### **Bid Addendum No. 1**

**Project:** ATHLETIC FIELD IMPROVEMENTS VETERANS MEMORIAL STADIUM AND CHESLEY PARK  
**Bid Number:** 3758  
**Subject:** BID CLARIFICATIONS  
**Date:** DECEMBER 6, 2013

SUBJECT:  
ADDED ENLARGED PLAN OF SYNTHETIC  
TURF FIELD CENTER LOGO

NEW BRITAIN ATHLETIC FIELD  
IMPROVEMENTS - VETS' STADIUM  
NEW BRITAIN, CONNECTICUT

F1 LOGO PLAN

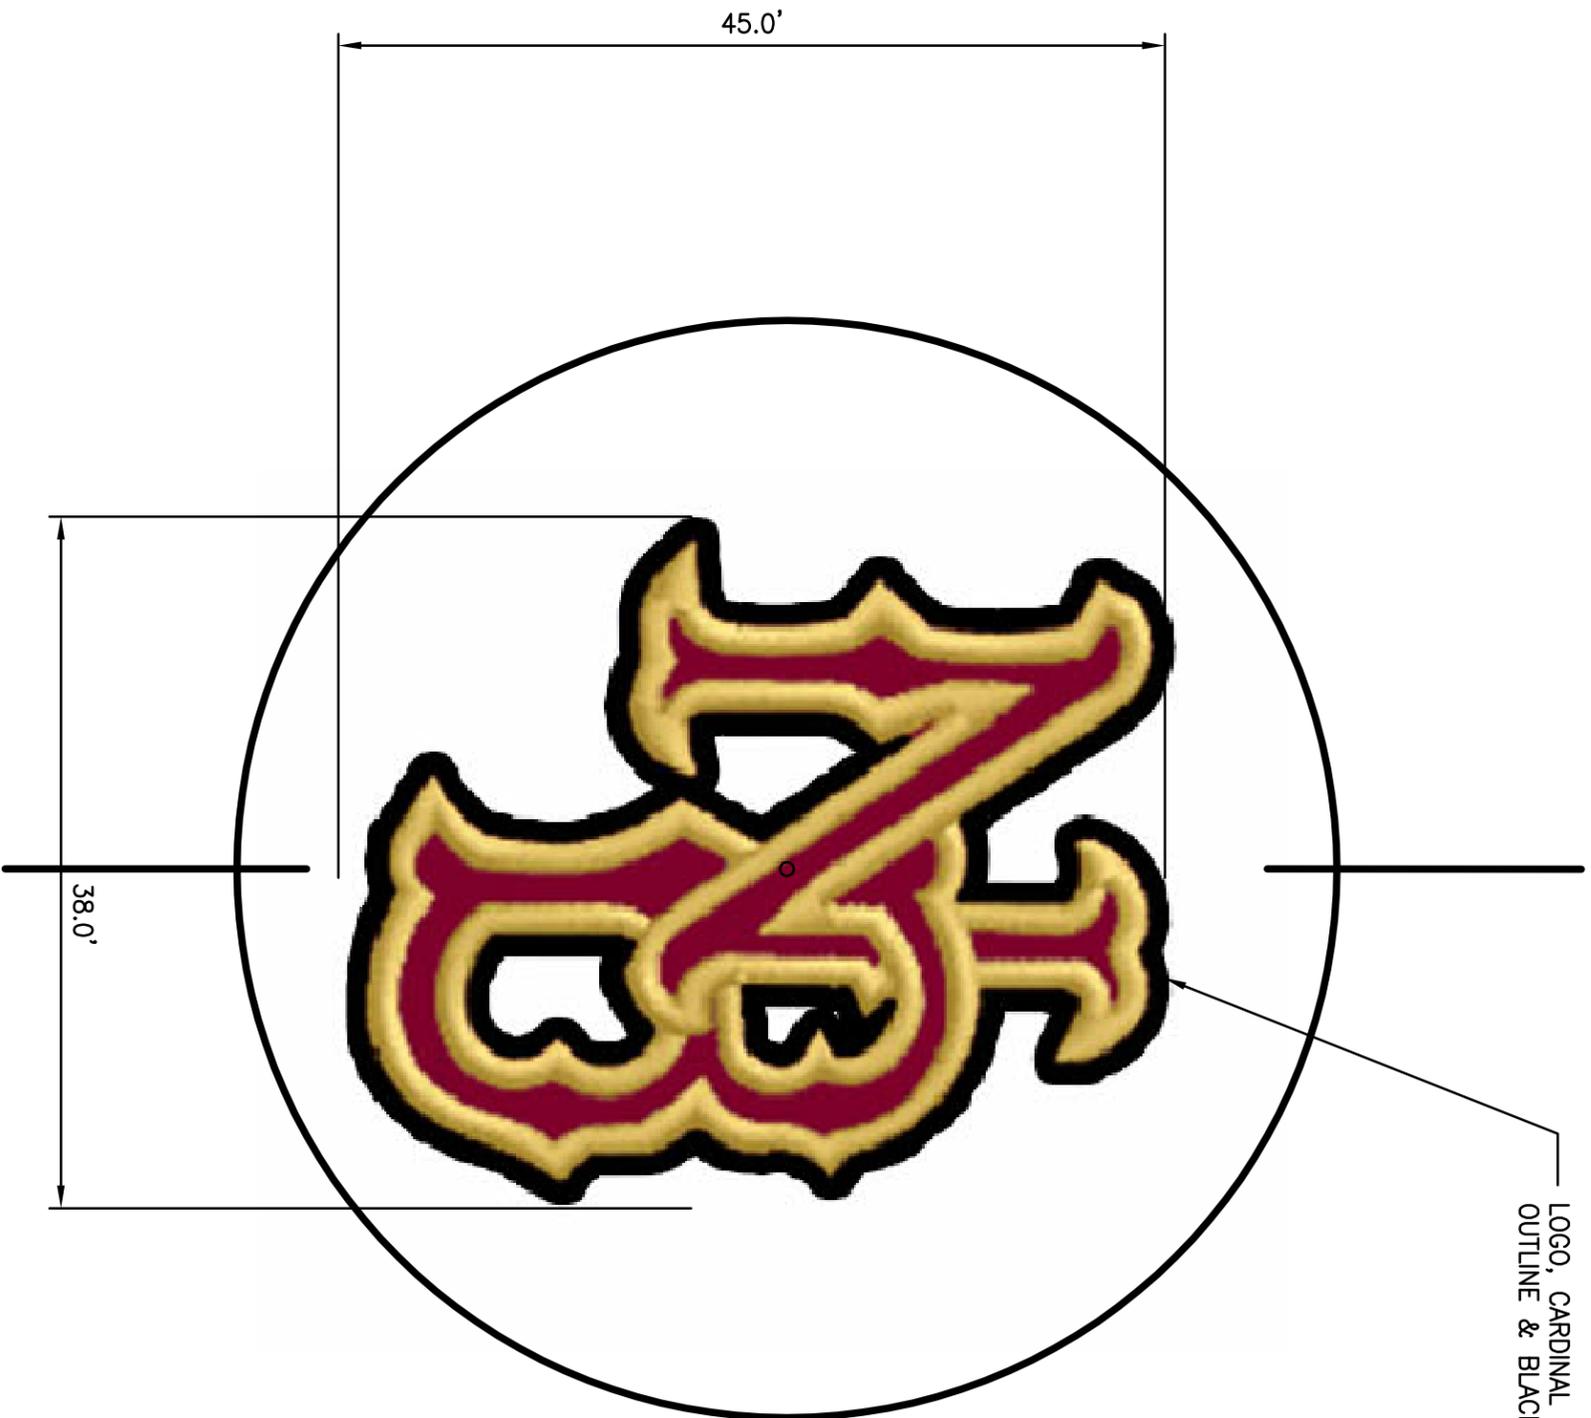
LOGO, CARDINAL RED LETTER CENTERS W/ LAS VEGAS GOLD  
OUTLINE & BLACK BORDER
